STAFF REPORT

File Number	PL 15-187	Contact	Steven Robertson, 218-730-5295	
Application Type	Variance, Side Yard Setback		Planning Commission Date	January 12, 2016
Deadline for Action	Application Date	December 15, 2015	60 Days	February 13, 2016
	Date Extension Letter Mailed	December 18, 2015	120 Days	April 13, 2016
Location of Subject	3427 Lake Avenue South			
Applicant	Lake Avenue South LLC	Contact	Bill Brownell and Pat Brownell Sterner	
Agent	Mike Medlin	Contact		
Legal Description	Lots 313 and 315 Lower Duluth Lake Avenue, and Northerly 25 feet of Lot 316 Lower Duluth			
Site Visit Date	January 4, 2016	Sign Notice Date	December 28, 2015	
Neighbor Letter Date	December 18, 2015	Number of Letters Sent	29

The applicant is proposing to add a 12.8' by 10' kitchen addition to an existing single family home within the R-1 side yard setback.

City Planning
PL 15-187
3427 Lake Ave S

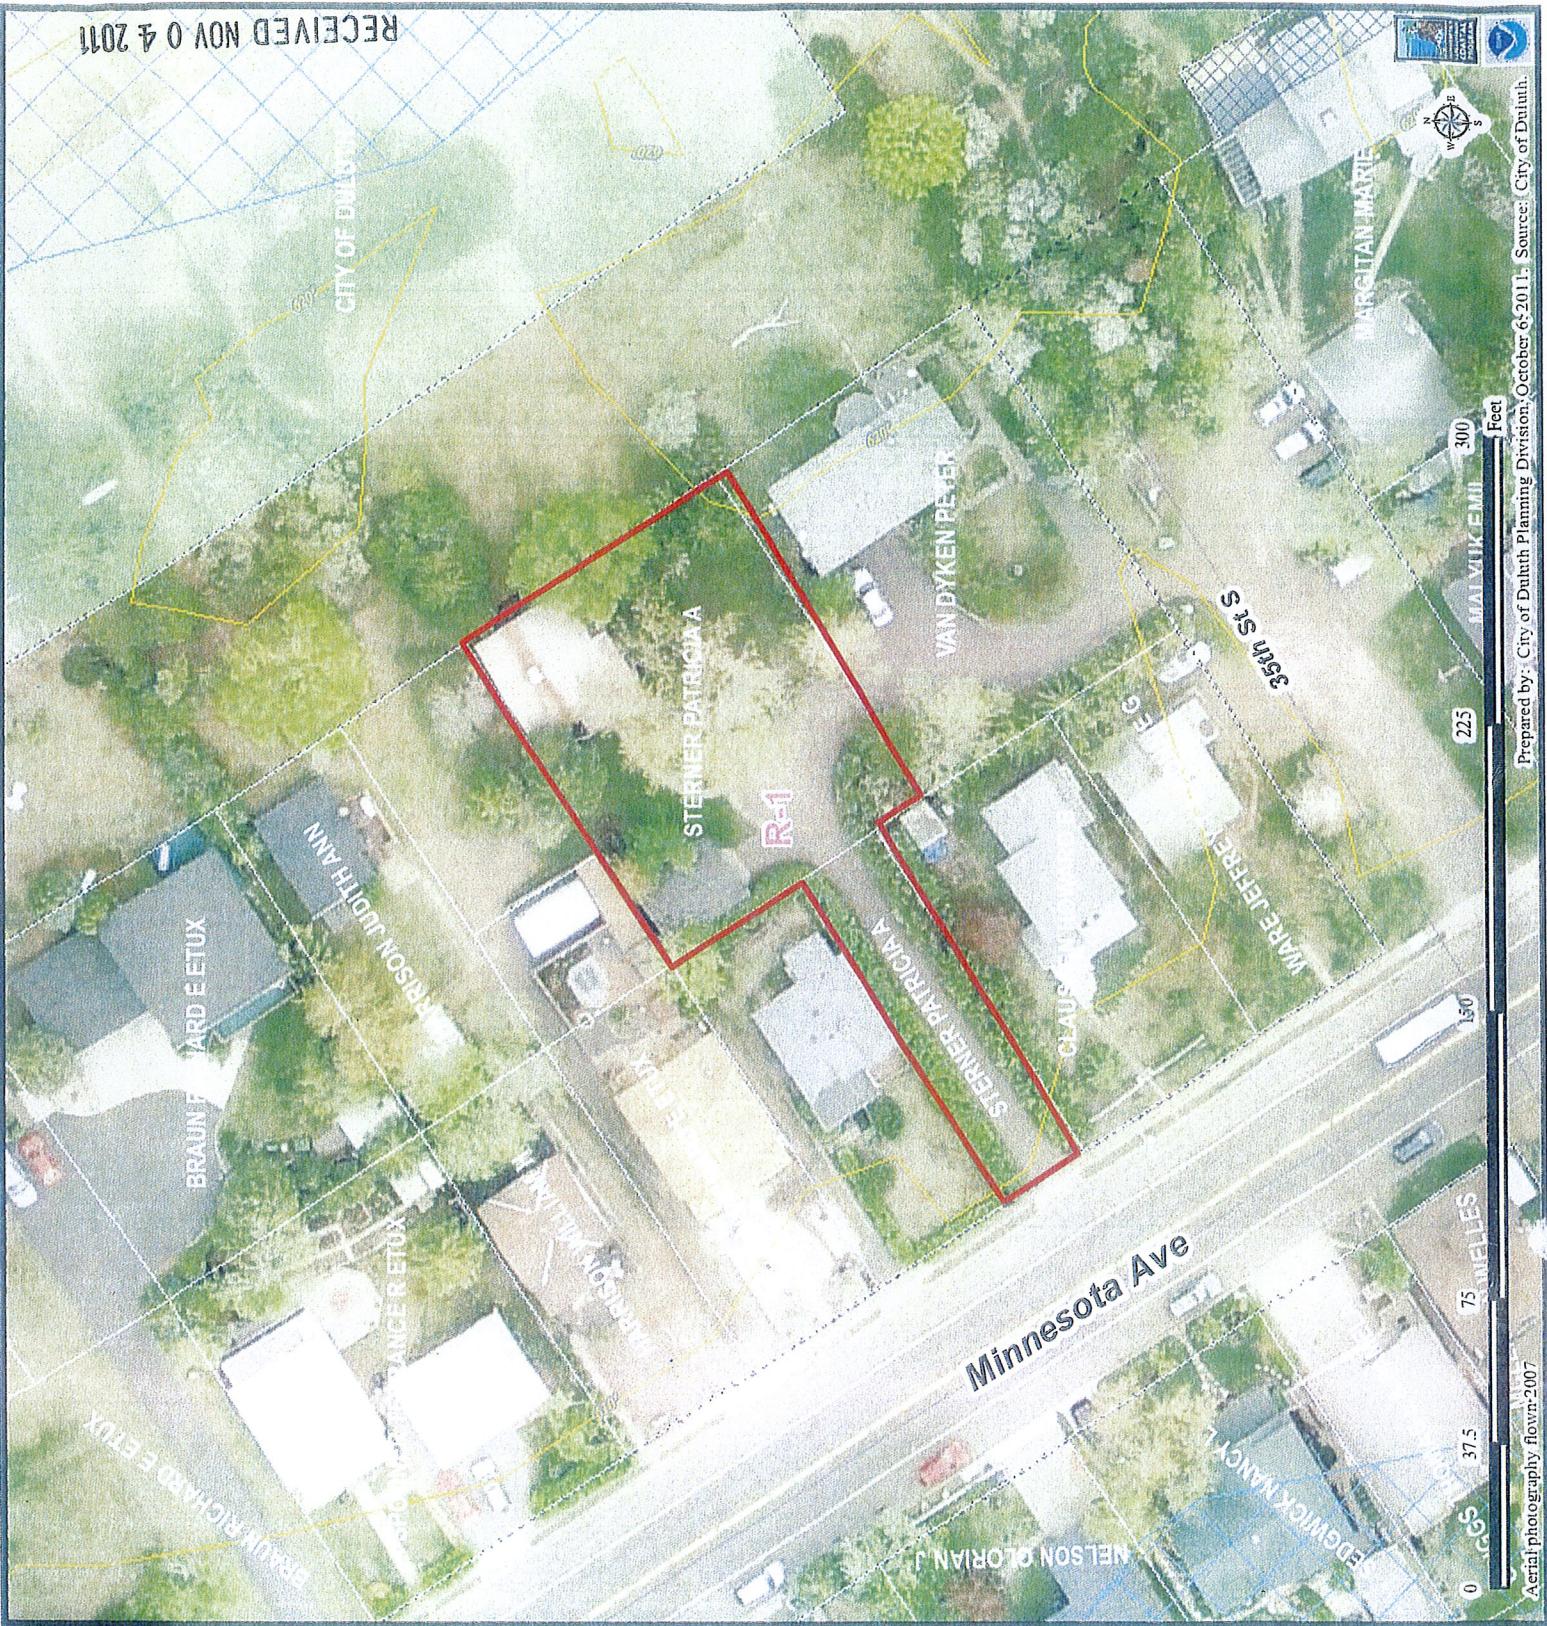
- 1.) The applicant's property is 80' wide by 100' deep with a 20' wide strip of land connecting it to Minnesota Avenue. It is improved with a 1,323 s.f. home and detached single-car garage. The attached site drawing shows in red dashed lines the building setbacks for this lot. The property is a size typical for Park Point. It is not exceptionally narrow, though 100' is shallower than most lots in the city.
